**JOINT REGIONAL PLANNING PANEL  
(Sydney East Region)**

<b>JRPP No</b>	<b>2013SYE062</b>
<b>DA Number</b>	<b>DA.205/11/2</b>
<b>Local Government Area</b>	<b>North Sydney</b>
<b>Proposed Development</b>	<b>Section 96 application to modify consent for demolition of existing buildings and structures, erection of a 31 storey commercial development with 5 levels of basement parking</b>
<b>Street Address</b>	<b>177-199 Pacific Highway North Sydney</b>
<b>Applicant</b>	<b>Winten (No13) Pty Ltd</b>
<b>Number of Submissions</b>	<b>Nil</b>
<b>Recommendation</b>	<b>Approval with Modified Conditions</b>
<b>Report by</b>	<b>Geoff Mossemeneear, Executive Planner, North Sydney Council</b>

**Assessment Report and Recommendation**

The changes to the western elevation are shown on a comparison of the photomontages below with the approved building again on the left.

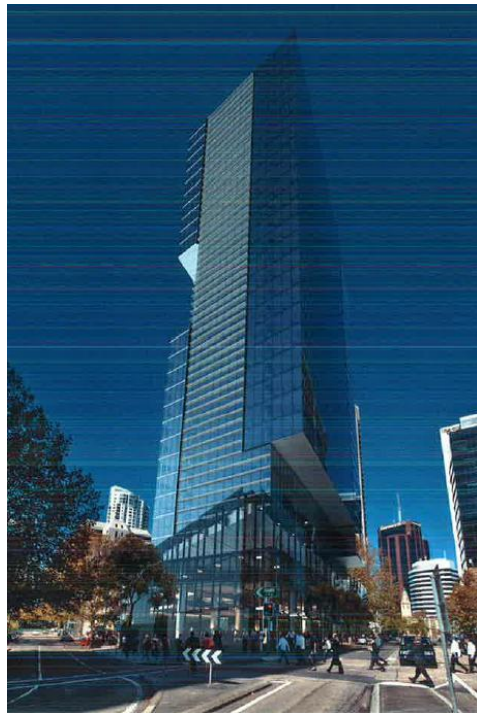
A specific requirement of the tenant is the need to accommodate its businesses across whole levels (i.e. not have staff from different business split across levels). In order to accommodate this requirement the floor plates on Levels 7 -9 have been extended 5m towards the Pacific Highway so that they can house the particular businesses that will be located on those levels. It is noted that this additional floor space to the three floor plates compensates for the cut out voids between floors to accommodate stair links. A comparison of the approved (left) and modified (right) floor plans are shown below:

Whilst the extension of the floor plates on those levels will reduce the setback, the height of the podium has been reduced to offset the extension and will result in a more appropriate scale and improved relationship to the streetscape. The proposed height of the podium will now match the height of the adjoining building at 173 Pacific Highway, and therefore be more consistent with Council's DCP which states that "podiums should match the height and setbacks of adjacent buildings".

The vertical articulation on the western elevation is also proposed to be narrowed in order to accommodate the changes to the building core. This change will not impact on the articulation of the western elevation.

The modifications proposed to the envelope are relatively minor in nature. The modifications will have no material impact on the approved overshadowing impacts, with the only additional shadow falling on the Pacific Highway and surrounding commercial buildings.

The public domain and public access was always an issue with the proposal and Council's Design Excellence Panel considered this aspect in detail with the original proposal. The approved ground floor plan is shown below:

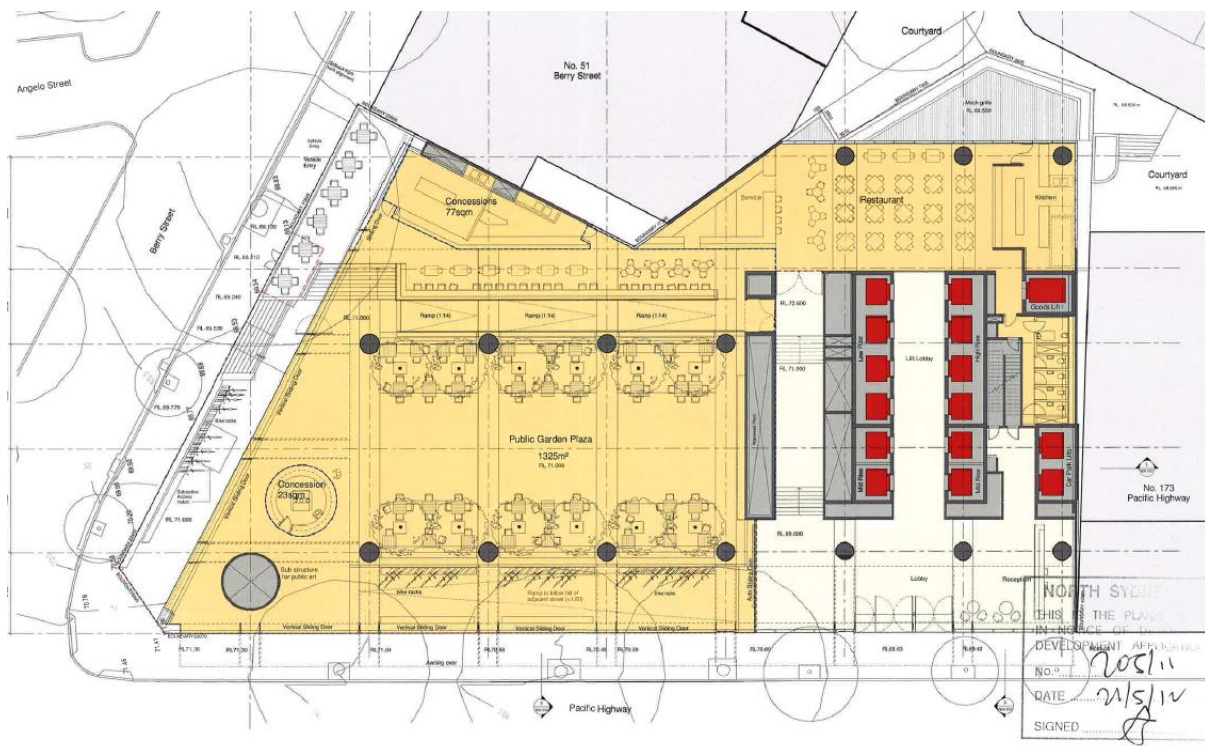
*C42. The levels of the setback of the building in Berry Street within 8m of the kerb shall be at grade to match the levels of the Berry Street footpath with no stairs, retaining walls, structures, awnings or balconies within the setback unless approved in writing by Council's Director of Engineering & Property Services. The glass of the podium facing Berry Street shall be generally 5m from the tower element without encroachment on the Berry Street Special Area. The exhaust ventilation shaft shall be located within the building.*

*C44. The setback of the glass of the podium, from the tower to the corner of Berry Street, facing the Pacific Highway shall be setback one metre from the boundary, with the setback to be finished at grade to match the levels of the Pacific Highway footpath.*

The proposed ground floor level is shown below:

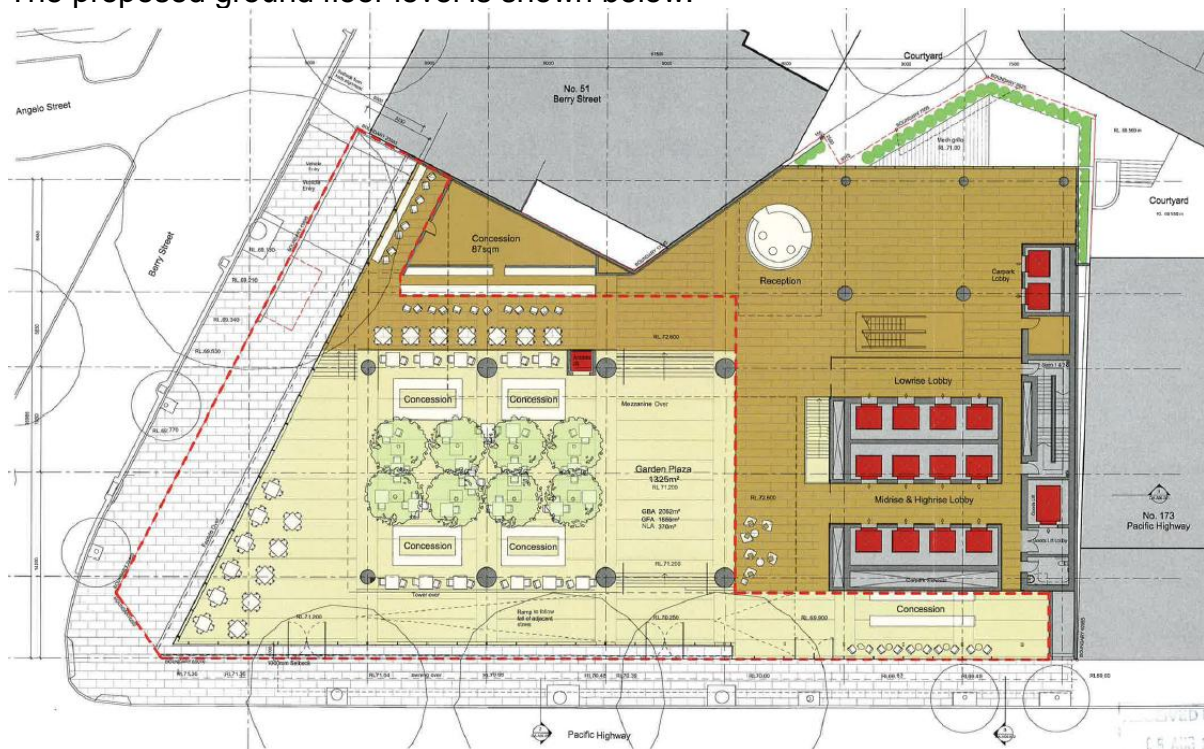
The 1m setback for the original proposal was limited to the Plaza frontage because the entry to the tower was to be separate and located at the south west corner. It is considered that the 1m setback should be extended for the whole of the Pacific Highway frontage to improve pedestrian comfort by widening the footpath particularly as the majority of pedestrian traffic from staff is likely to come along the Highway from the Station to the south and entering the site closer to Berry Street. Any redevelopment of the adjoining site to the south should have a similar setback. This could not happen if only part of the frontage on the subject site is setback. The additional setback will not impact on the upper levels on the proposal.

With regard to Berry Street, it was never intended that public access not be available from the northern frontage to the Garden Plaza. There would be considerable pedestrian movement from visitors to the Plaza from east along Berry Street. A double door entry point is essential to activate this part of the public domain. Although entry is not at grade with the footpath, stairs could be provided (within or partly within) the site to the lower level of the plaza. The bike racks can be relocated and are not necessarily required to be in this location. The setback at Berry Street and the entry needs to be designed the satisfaction of Council's Director of Engineering & Property Services so that there are consistent finishes in the public domain.

The recommended increased widening to Pacific highway and a public entry to Berry Street are considered to be reasonable and practical and can be conditioned.

- C42. The levels of the setback of the building in Berry Street within 8m of the kerb shall be at grade to match the levels of the Berry Street footpath with no stairs, retaining walls, structures, **cycle racks**, awnings or balconies within the setback unless approved in writing by Council's Director of Engineering & Property Services. **A pedestrian entrance (similar width to the entry doors from the Highway) shall be provided from Berry Street to the Garden Plaza.**

- C44. The setback of the glass of the podium, facing the Pacific Highway **for the entire frontage** shall be setback one metre from the boundary, with the setback to be finished at grade to match the levels of the Pacific Highway footpath.
